INDESIT company

Model type:
AML129EU

Commercial code:
F030598

n1040325: New shock absorber fixing system with pin

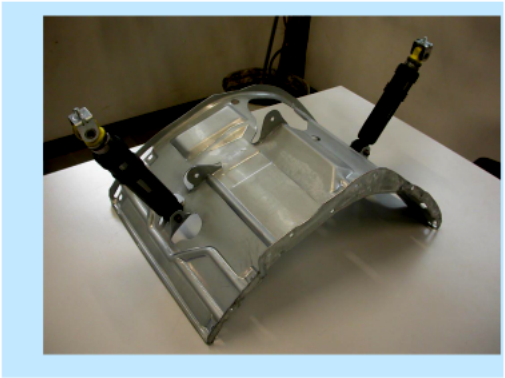
From serial no. 40427.0001, shock absorbers have been fixed to the tank unit cradle with two 11 mm pins code C00110163 (see fig. 01 and 02 enclosed) in place of the 8 mm screws code 093750 and relevant locking nuts code 030443, on all washing

machines and dryers produced in the Comunanza factory.
The items affected by this modification are:
1) The cradles have the same Service code, as they can be used in place of the new ones after widening the shock absorber fixing holes to a diameter of 10 mm.
Code 093848 - Tank unit cradle 46 lt
Code 093878 - Tank unit cradle 40 lt.
2) The new shock absorbers, with fixing bushing having no s/steel spacer, are not managed as they are interchangeable with the premodified items (make sure they are CIMA type, as the managed items), fixed with M8 screws code 093750 and related locking nut code 030443 (see figs. 05 and 06).
Code 093884 - Shock absorber 80 N
Code 093885 - Shock absorber 100 N

To remove the shock absorber from the tank, first extract the pin with a few hammer taps (see fig.03) until it is aligned with the tank bracket and then pull it out with a pair of pliers (see fig. 04).
(To refit the shock absorber use a new pin. Insert the pin until the toroidal edge is aligned with the bracket.)

Fig. n10402231

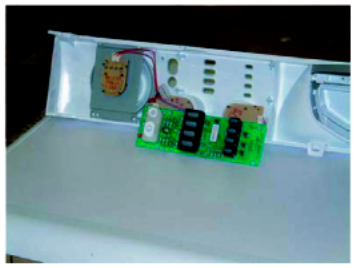
From serial no. 40429.0001, models AVL, AVXL, AVSL, AML have been equipped with a new panel with well holes for the ON/OFF and RESET buttons and flush plastic light diffusers in place of the projecting siliconed ones (see picture n10402231

Fig. n10402232

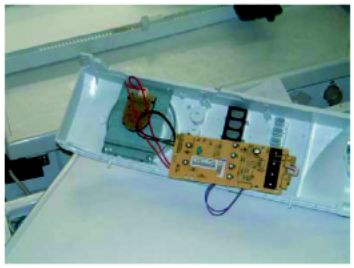
Fig.02). These features determine whether an appliance is modified or premodification.
The modification has also involved the electronic card whose panel and display communication connectors are on the left and not at the back (see picture n10402232 Fig.2).

n1040342: New balancing system for washer-dryer models with spin cycle up to 1200 rpm.

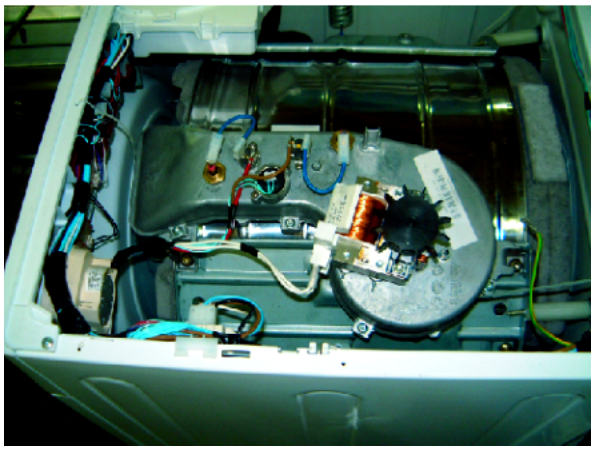
From serial number 41026.0001, all WIDL, AML, AMD washer-dryer models up to 1200 rpm produced in the Comunanza plant are equipped with a new balancing system for the mobile assembly (see fig.001).
The modification involves the following parts, which are not interchangeable with their premodification equivalents:

C00114386 - REAR COUNTERWEIGHT WD 6 kg;
C00114388 - DRYER KIT BLOWER BODY S/N 41026.0001;
C00114390 - BLOWER BODY FIXING SCREW SN 41026 M8X25S.P.P.
C00114487 - REAR COUNTER-WEIGHT FIXING SCREW M8X32TE.
In preparation for this modification, drum spiders already prearranged with fixing holes for the rear counter-weight (see attached image) have been installed on production appliances and included in the spare parts programme.

Fig . 001

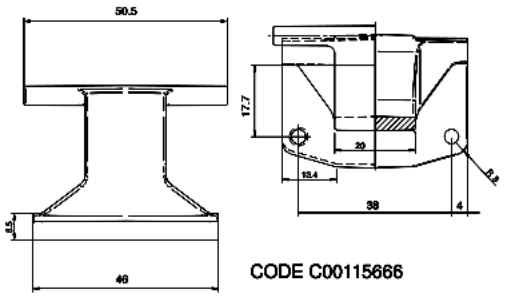
From serial no. 50207.0001, all Ariston models produced in the Teverola factory (see table 001 attached) with industrial code (given on the rating plate) starting with 46, have been equipped with a Zamac hinge with 150° opening angle, code C00115666 (see Fig.001).
This modification has involved the introduction of the following items:

Code C00115670 - Complete door EVOII 150° white 27 with standard glass;
Code C00115674 - Complete door EVOII 150° white 27 with long glass;
Code C00115667 - EVOII body for 150° hinge white 27;

Fig . 001

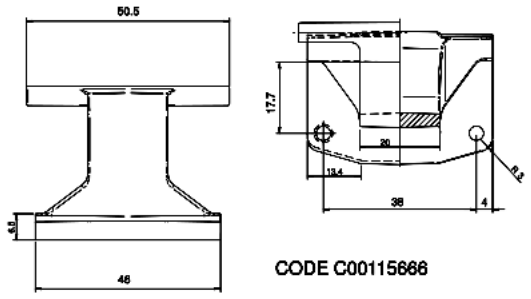
From serial no. 50207.0001, all Ariston models produced in the Comunanza factory (see table 001 attached) with industrial code (given on the rating plate) starting with 80, have been equipped with a Zamac hinge with 150° opening angle, code C00115666 (see Fig.001).
This modification has involved the introduction of the following items:

Code C00115670 - Complete door EVOII 150° white 27 with standard glass;
Code C00115674 - Complete door EVOII 150° white 27 with long glass;
Code C00115668 - Complete door EVOII 150° silver with standard glass;
Code C00115673 - Complete door EVOII 150° silver snella standard glass;
Code C00115662 - EVOII body for 150° hinge white 27
Code C00115663 - EVOII body for 150° hinge silver 27
Code C00115664 - Snella EVOII body for 150° hinge white 27
Code C00115665 - Snella EVOII body for 150° hinge silver

n4008f00: Thermic link wire removed on three-phase motor

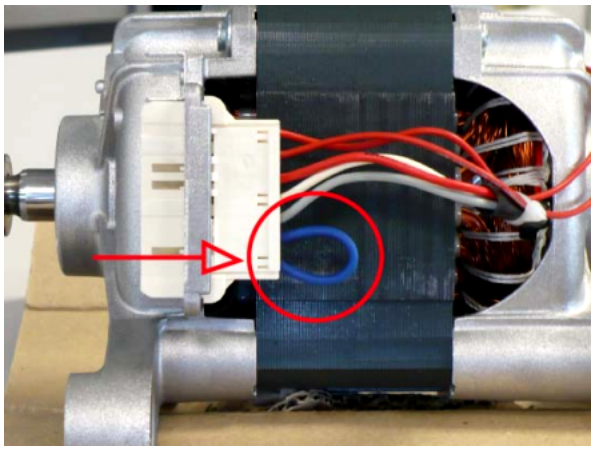
Attention!
When you assist the premodification models using the new motor code you MUST use the thermic link wire code C00265838.

In the attached image you can see the fixing of thermic link wire in the motor therminal box.
